**REMARKS/ARGUMENTS**

(For the Examiner's convenience the paragraph numbers below correspond to the paragraph numbers in the Office Action.)

FIG. 5

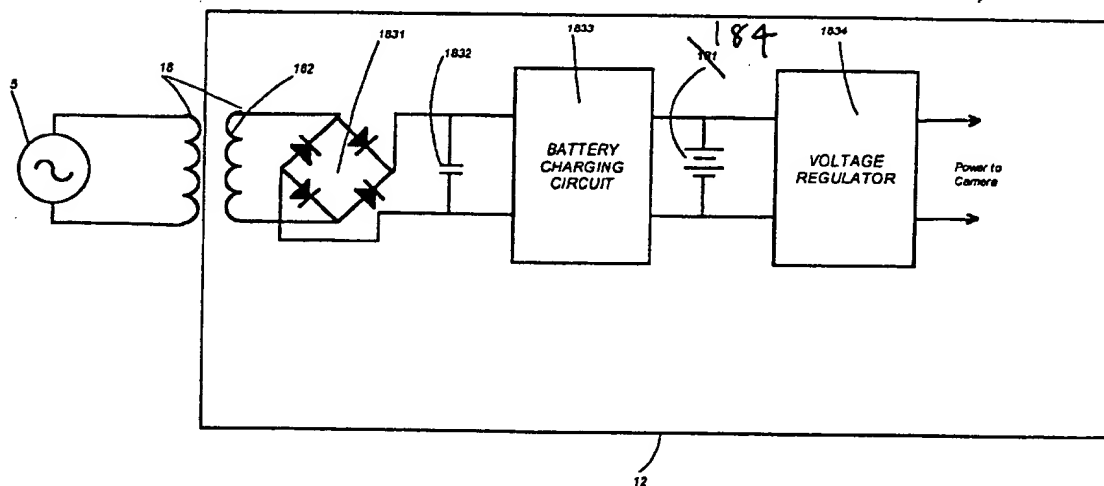
5. The drawings are objected to as failing to comply with 37 CFR 1.84(p)(4) because reference character “181” has been used to designate both a power switch (Figure 1) and a battery (Figure 5).

The attached sheets of drawings include changes to Figs. 5 and 8. The sheet including Figs. 4 and 5, replaces the original sheet including Figs. 4 and 5. In Figure 5, reference number 181 has been amended to 184. The sheet including Fig. 8, replaces the original sheet including Fig. 8. In Figure 8, reference number 373a for the antennas has been added.

Applicant has amended reference number 181 to 184 on Figure 5. Applicant has also noted that the battery had been associated with reference numbers 181 and 183 in the specification and has corrected these typographical errors also.
